H. B. ROBINSON STEAM ELECTRIC PLANT, UNIT NO. 2
DOCKET NO. 50-261/LICENSE NO. DPR-23

RESPONSE TO REQUEST FOR ADDITIONAL INFORMATION
FOR RELIEF REQUEST PERTAINING TO EXAMINATION COVERAGE
LESS THAN ESSENTIALLY 100 PERCENT (RELIEF REQUEST NO. 34)

RESPONSE TO REQUEST FOR ADDITIONAL INFORMATION FOR RELIEF REQUEST PERTAINING TO EXAMINATION COVERAGE LESS THAN ESSENTIALLY 100 PERCENT (RELIEF REQUEST NO. 34)

Figure 1

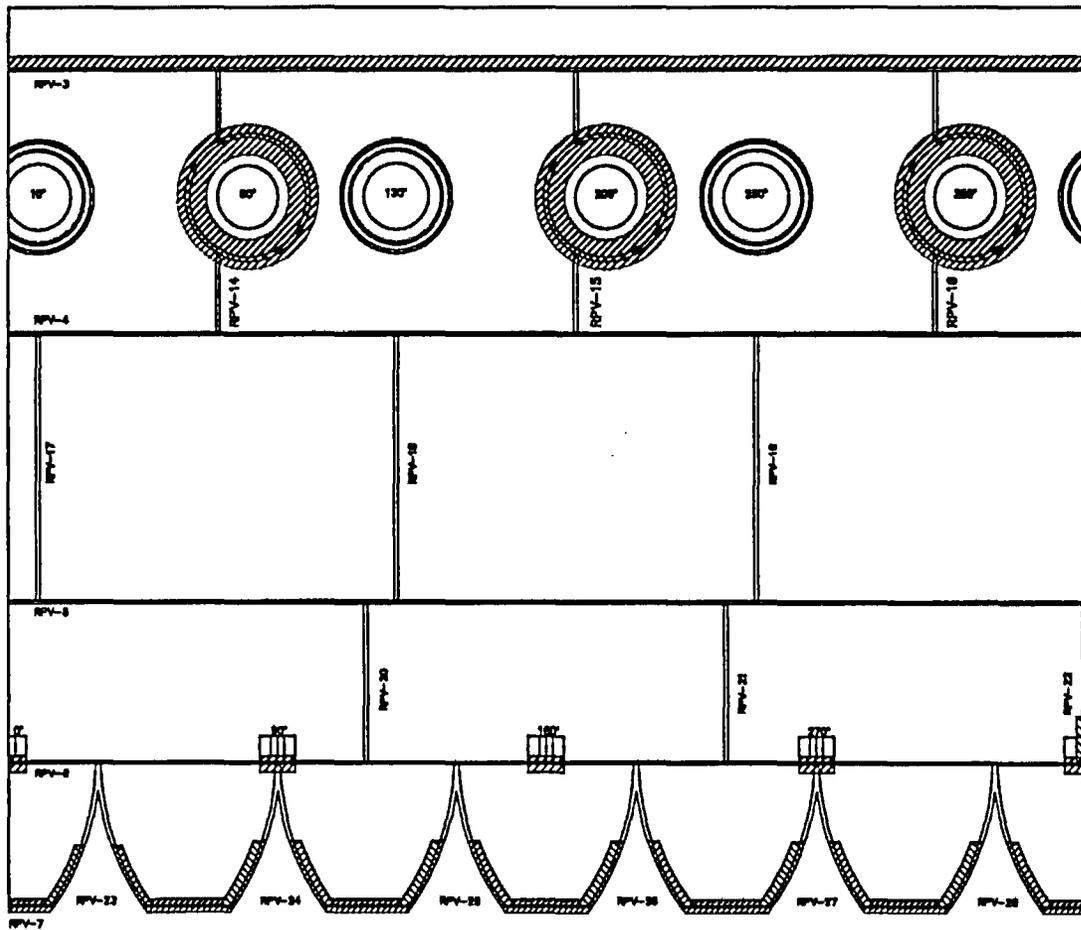
Automated scanning of the RPV lower head meridional welds (101/23, 101/24, 101/25, 101/26, 101/27, and 101/28) was limited due to interference from the instrumentation tubes and the core support lugs. Figure 1 is a roll-out inside view of the reactor pressure vessel showing the scan limitations. Figure 2 provides a side section view of the meridional welds showing the limited scanning areas.

The automated scanning of the lower head ring-to-lower head weld (101/07) was limited due to interference from the lower head bottom-mounted instrumentation (BMI) tubes. Figure 1 is a roll-out inside view of the reactor pressure vessel showing the scan limitations. Figure 3 shows a top view of the parallel scanning limitation and a side view of the transverse scanning limitations.

Examination of the lower head-to-lower shell weld (101/06) was limited due to interference from the core support lugs. Figure 1 shows the inside roll-out view and Figure 4 shows a side view of the limited area.

Examination of the lower shell longitudinal weld (101/22) was limited due to interference from the core support lug at 0°. Figure 1 is a roll-out inside view showing scan limitations. Figure 6 shows the side view of the limited area.

The transverse examination of the upper shell-to-flange weld (101/03) was limited due to the flange configuration. The tapered surface on the flange side did not allow transverse scanning. Figure 1 is a roll-out inside view showing scan limitations. Figure 5 shows a side view of the limited area.

Figure 1

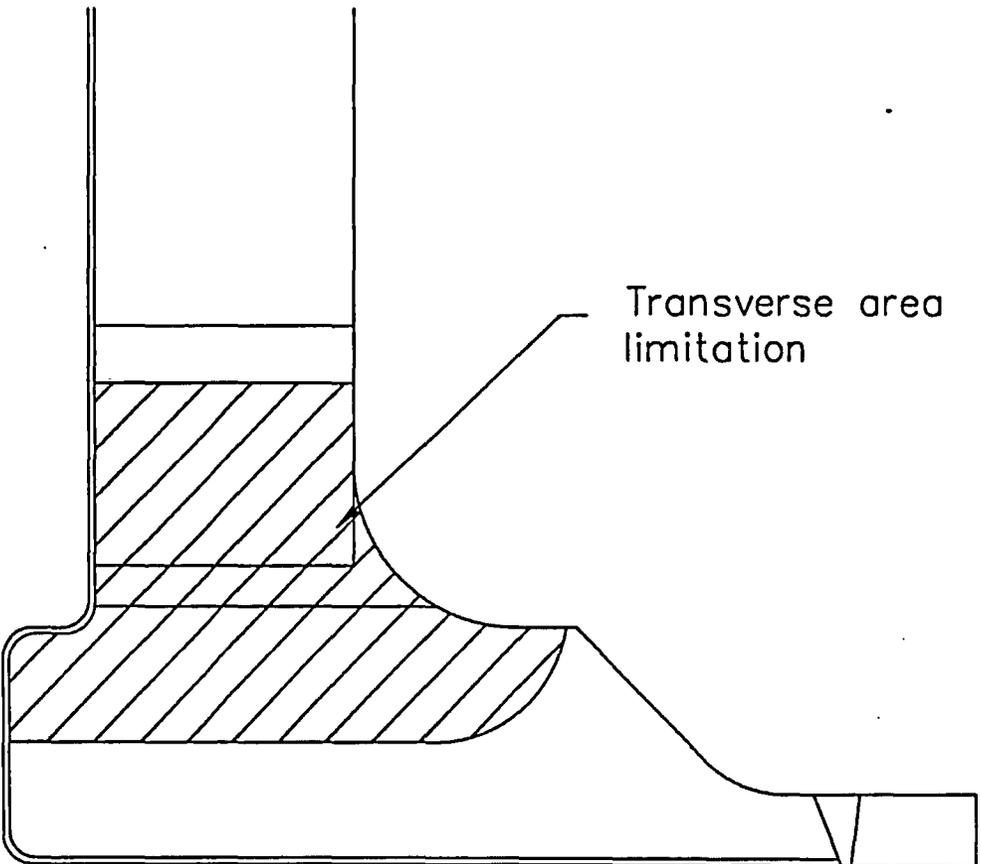
Automated scanning (transverse examination only) of the outlet nozzle to shell welds (101A/29, 101A/31, and 101A/33) was limited due to interference from the nozzle integral extension. Figure 1 provides a side section view of the outlet nozzle to shell welds showing the limited scanning areas.

ROBINSON UNIT #2
WELD # 107/04DM

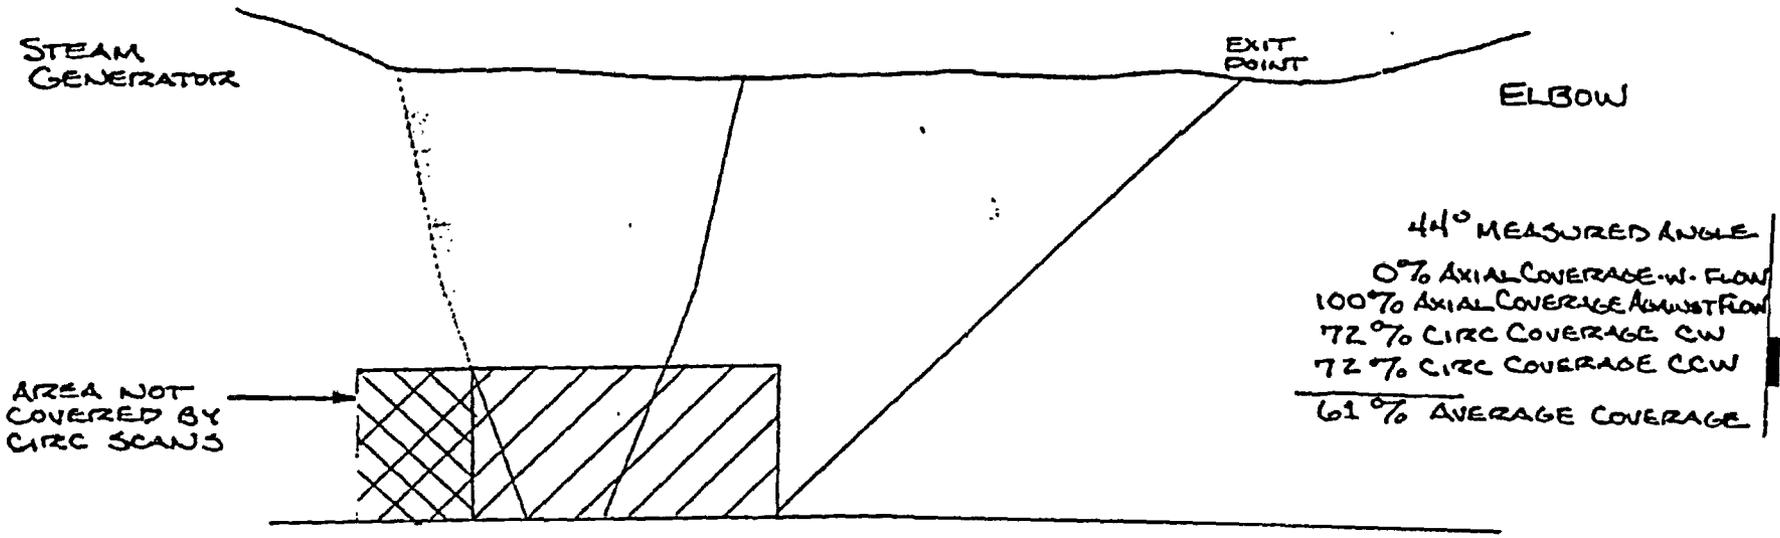
COMPONENT ID:	107/04DM	ASME CATEGORY:	B-F
ASME CODE FIGURE:	IWB-2500-8	ASME ITEM NUMBER:	B5.70
CONFIGURATION	ELBOW TO NOZZLE	% CRV ACHIEVED:	61%
PDI TECHNIQUE USED:	NO	EXAM DATE:	10/3/93

COMPONENT ID:	107A/04DM	ASME CATEGORY:	B-F
ASME CODE FIGURE:	IWB-2500-8	ASME ITEM NUMBER:	B5.70
CONFIGURATION	ELBOW TO NOZZLE	% CRV ACHIEVED:	60.35%
PDI TECHNIQUE USED:	NO - WESTINGHOUSE TECHNIQUE PER WCAP 11778 UTILIZED	EXAM DATE:	3/18/98

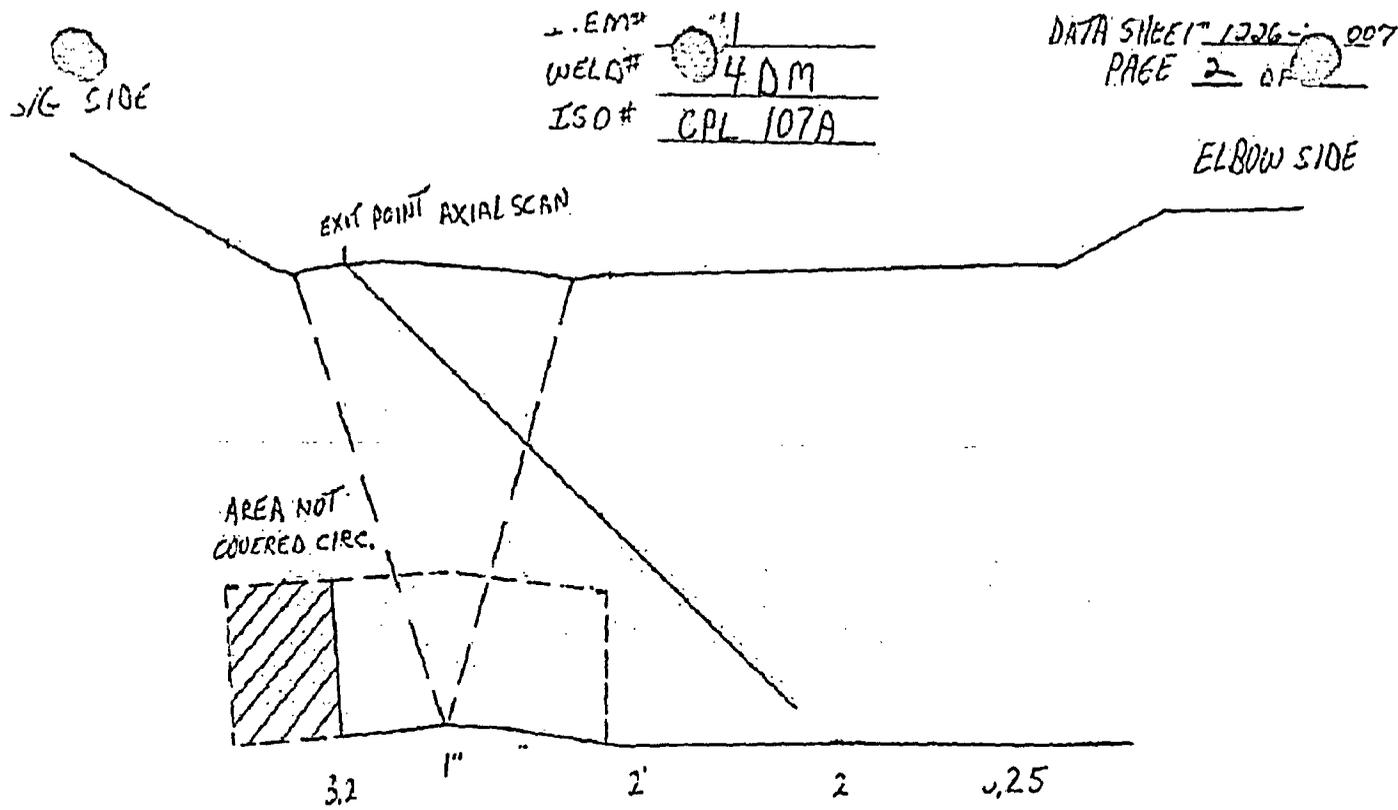
SCAN	% VOLUME ACHIEVED	LIMITATION
1	100%	NONE
2	0%	NO SCAN DUE TO CAST STAINLESS STEEL ELBOW TO CARBON CAST NOZZLE CONFIGURATION.
3	70.7%	1/2V SINGLE SIDED EXAM DUE TO CAST STAINLESS STEEL ELBOW TO CARBON CAST NOZZLE CONFIGURATION.
4	70.7%	1/2V SINGLE SIDED EXAM DUE TO CAST STAINLESS STEEL ELBOW TO CARBON CAST NOZZLE CONFIGURATION.

COMPONENT ID:	107A/05DM	ASME CATEGORY:	B-F
ASME CODE FIGURE:	IWB-2500-8	ASME ITEM NUMBER:	B5.70
CONFIGURATION	NOZZLE TO ELBOW	% CRV ACHIEVED:	60.52%
PDI TECHNIQUE USED:	NO – WESTINGHOUSE TECHNIQUE PER WCAP 11778 UTILIZED	EXAM DATE:	3/18/98

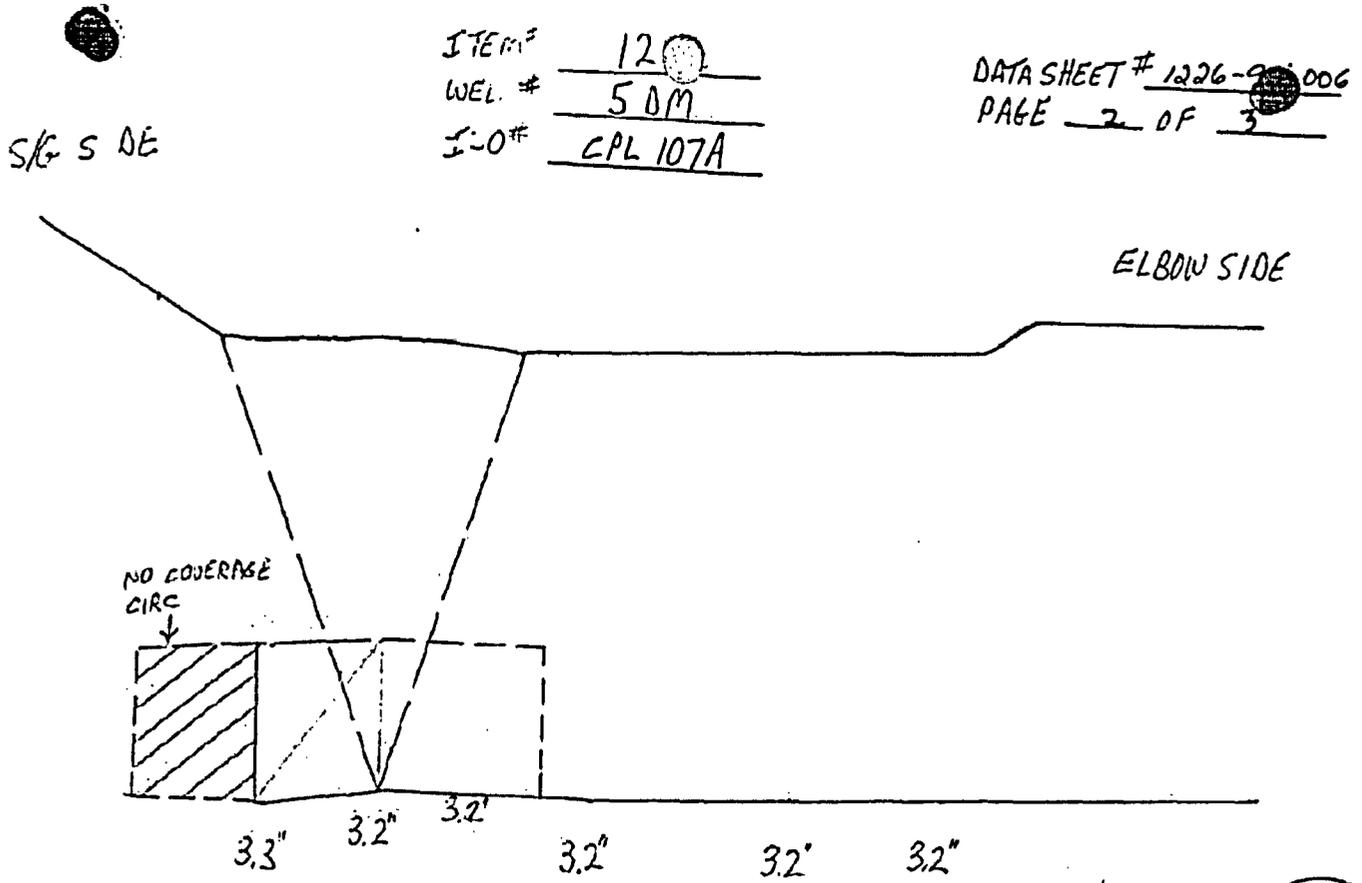
SCAN	% VOLUME ACHIEVED	LIMITATION
1	0%	NO SCAN DUE TO CAST STAINLESS STEEL ELBOW TO CARBON CAST NOZZLE CONFIGURATION.
2	100%	NONE
3	71%	1/2V SINGLE SIDED EXAM DUE TO CAST STAINLESS STEEL ELBOW TO CARBON CAST NOZZLE CONFIGURATION.
4	71%	1/2V SINGLE SIDED EXAM DUE TO CAST STAINLESS STEEL ELBOW TO CARBON CAST NOZZLE CONFIGURATION.

COMPONENT ID:	107B/04DM	ASME CATEGORY:	B-F
ASME CODE FIGURE:	IWB-2500-8	ASME ITEM NUMBER:	B5.70
CONFIGURATION	ELBOW TO NOZZLE	% CRV ACHIEVED:	51.50%
PDI TECHNIQUE USED:	YES	EXAM DATE:	5/25/01

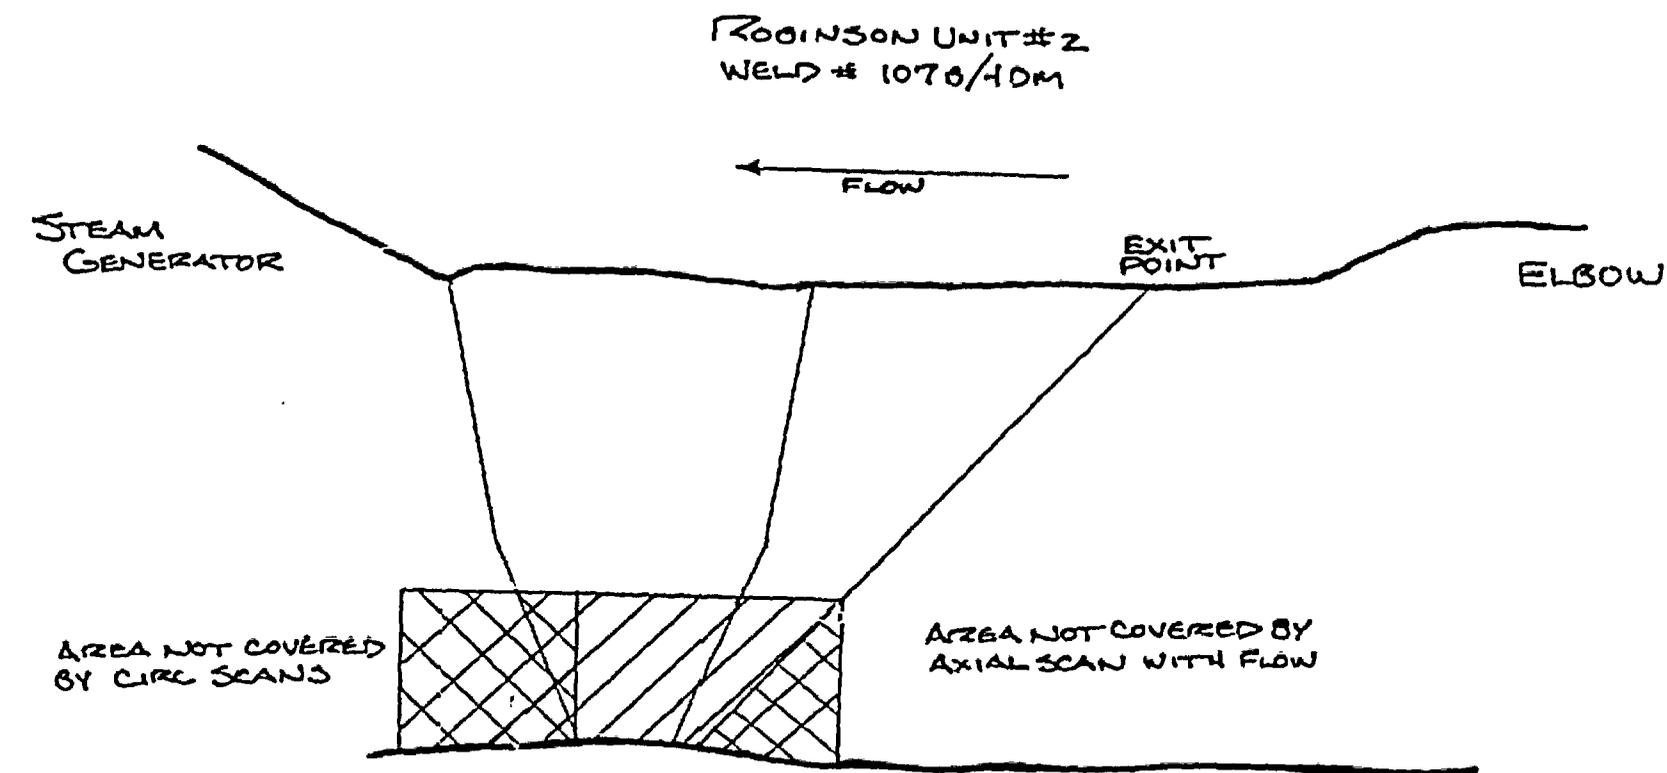
SCAN	% VOLUME ACHIEVED	LIMITATION
1	84%	1/2V SINGLE SIDED EXAM DUE TO CAST STAINLESS STEEL ELBOW TO CARBON CAST NOZZLE CONFIGURATION.
2	0%	NO SCAN DUE TO CAST STAINLESS STEEL ELBOW TO CARBON CAST NOZZLE CONFIGURATION.
3	61%	1/2V SINGLE SIDED EXAM DUE TO CAST STAINLESS STEEL ELBOW TO CARBON CAST NOZZLE CONFIGURATION.
4	61%	1/2V SINGLE SIDED EXAM DUE TO CAST STAINLESS STEEL ELBOW TO CARBON CAST NOZZLE CONFIGURATION.

COMPONENT ID:	107B/05DM	ASME CATEGORY:	B-F
ASME CODE FIGURE:	IWB-2500-8	ASME ITEM NUMBER:	B5.70
CONFIGURATION	NOZZLE TO ELBOW	% CRV ACHIEVED:	55.75%
PDI TECHNIQUE USED:	YES	EXAM DATE:	4/20/01

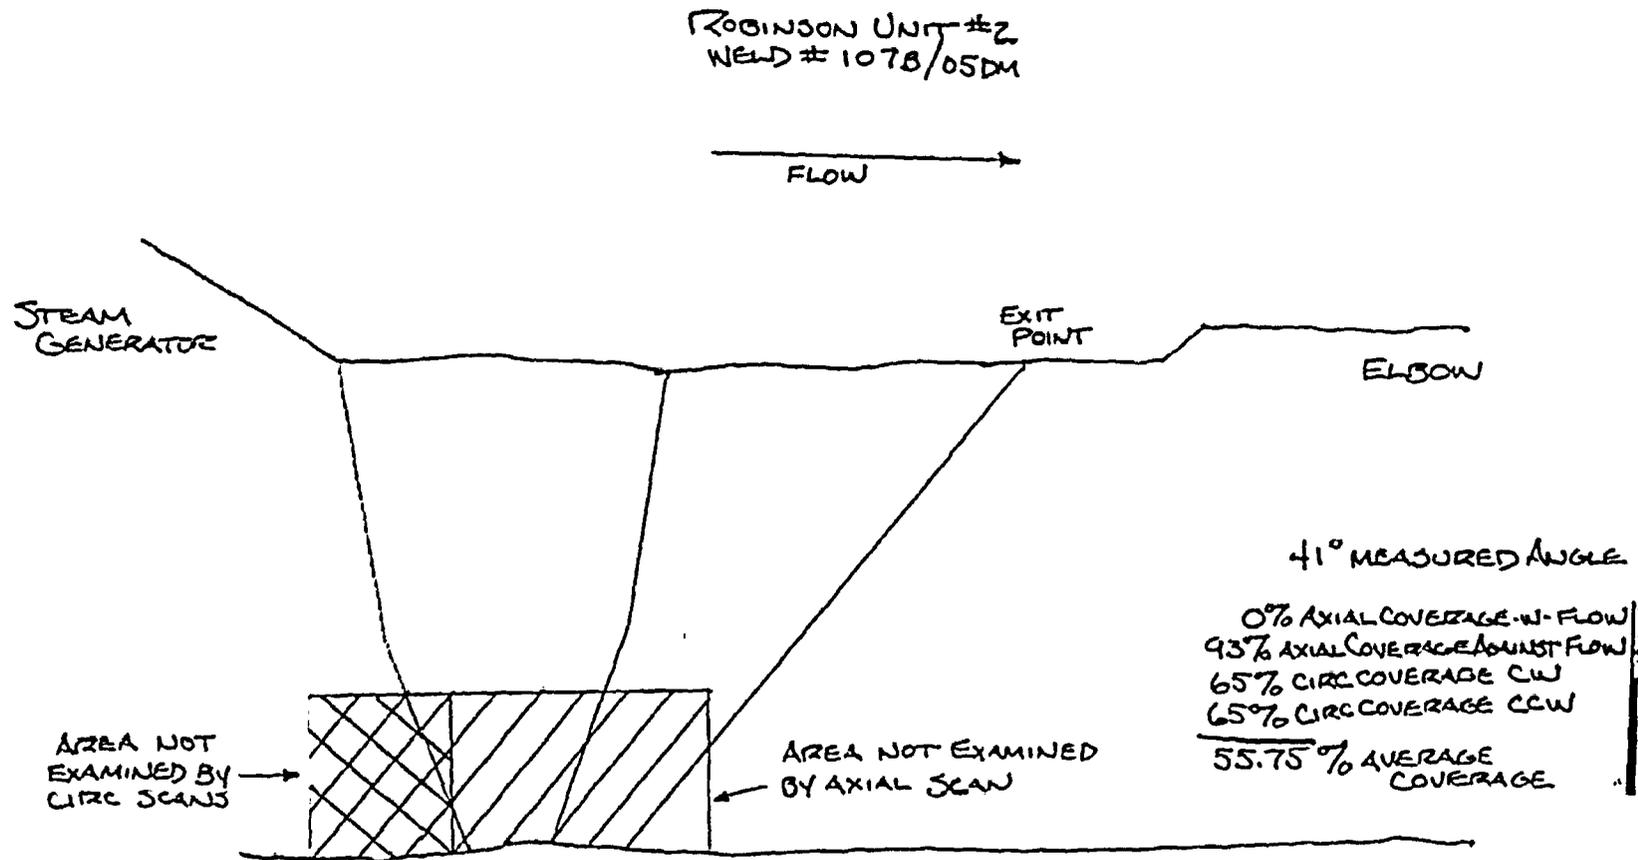
SCAN	% VOLUME ACHIEVED	LIMITATION
1	0%	NO SCAN DUE TO CAST STAINLESS STEEL ELBOW TO CARBON CAST NOZZLE CONFIGURATION.
2	93%	1/2V SINGLE SIDED EXAM DUE TO CAST STAINLESS STEEL ELBOW TO CARBON CAST NOZZLE CONFIGURATION.
3	65%	1/2V SINGLE SIDED EXAM DUE TO CAST STAINLESS STEEL ELBOW TO CARBON CAST NOZZLE CONFIGURATION.
4	65%	1/2V SINGLE SIDED EXAM DUE TO CAST STAINLESS STEEL ELBOW TO CARBON CAST NOZZLE CONFIGURATION.

COMPONENT ID:	107A/07	ASME CATEGORY:	B-J
ASME CODE FIGURE:	IWB-2500-8	ASME ITEM NUMBER:	B9.11
CONFIGURATION:	PIPE TO ELBOW	% CRV ACHIEVED:	84%
PDI TECHNIQUE USED:	NO - WESTINGHOUSE TECHNIQUE PER WCAP-11778 UTILIZED	EXAM DATE:	3/19/98

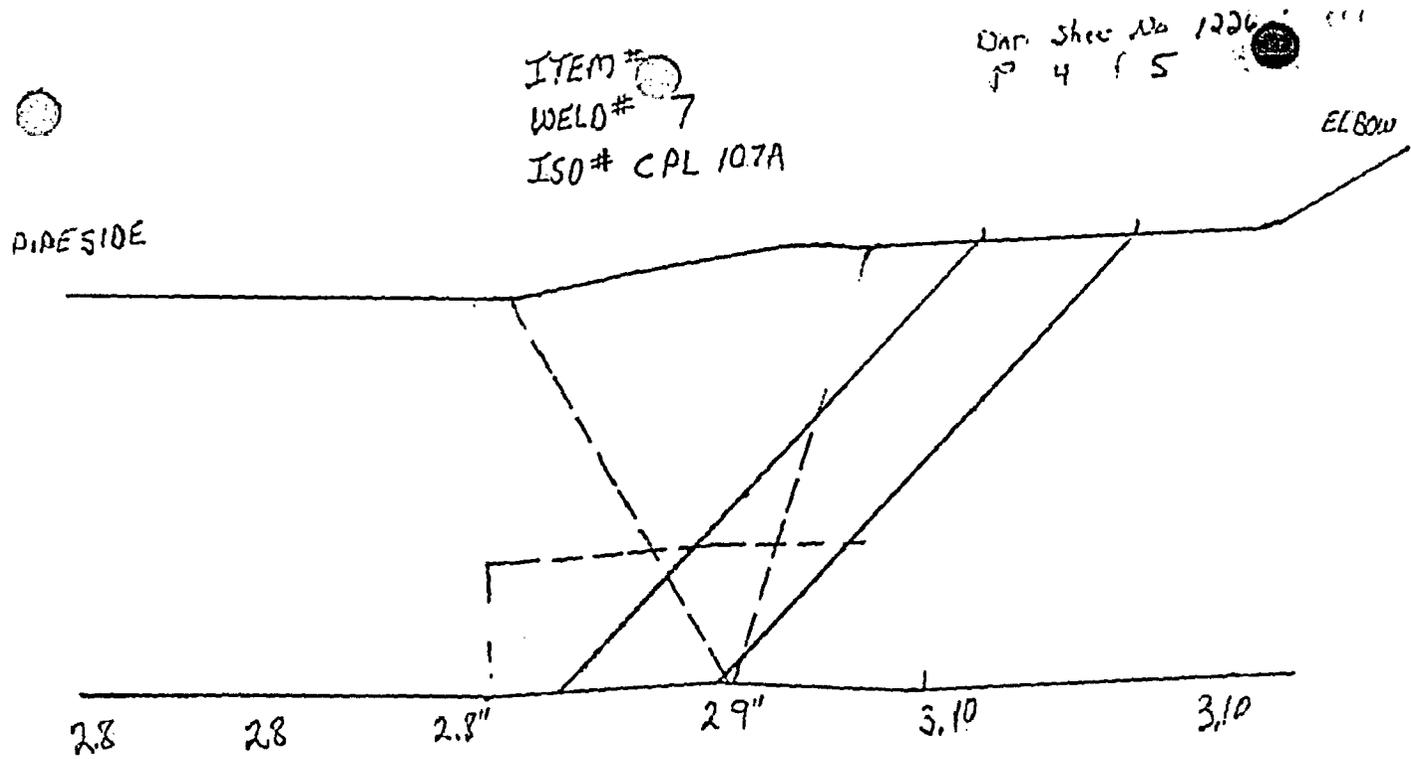
SCAN	% VOLUME ACHIEVED	LIMITATION
1	100%	NONE
2	36%	1/2V SINGLE SIDED EXAM DUE TO PIPE TO CAST STAINLESS STEEL ELBOW CONFIGURATION.
3	100%	NONE
4	100%	NONE

COMPONENT ID:	112/01BC	ASME CATEGORY:	B-J
ASME CODE FIGURE:	IWB-2500-10	ASME ITEM NUMBER:	B9.31
CONFIGURATION:	BRANCH CONNECTION TO LOOP PIPE	% CRV ACHIEVED:	60%
PDI TECHNIQUE USED:	YES	EXAM DATE:	5/3/01

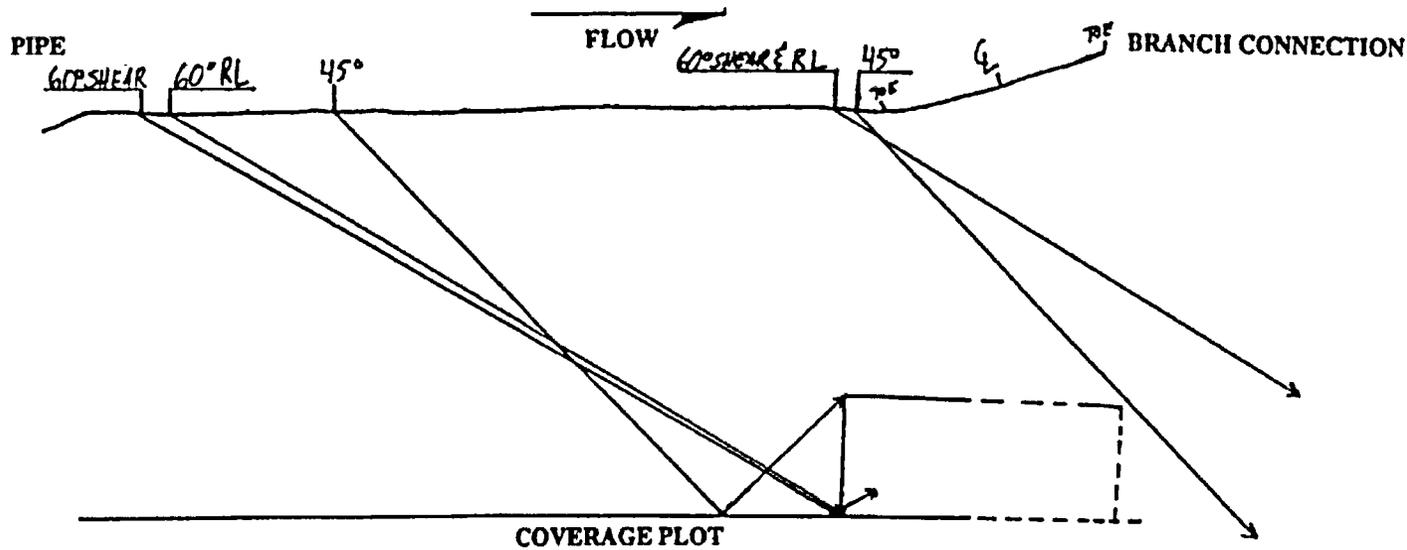
SCAN	% VOLUME ACHIEVED	LIMITATION
1	100%	NONE
2	0%	NO SCAN DUE TO BRANCH CONNECTION TO PIPE CONFIGURATION.
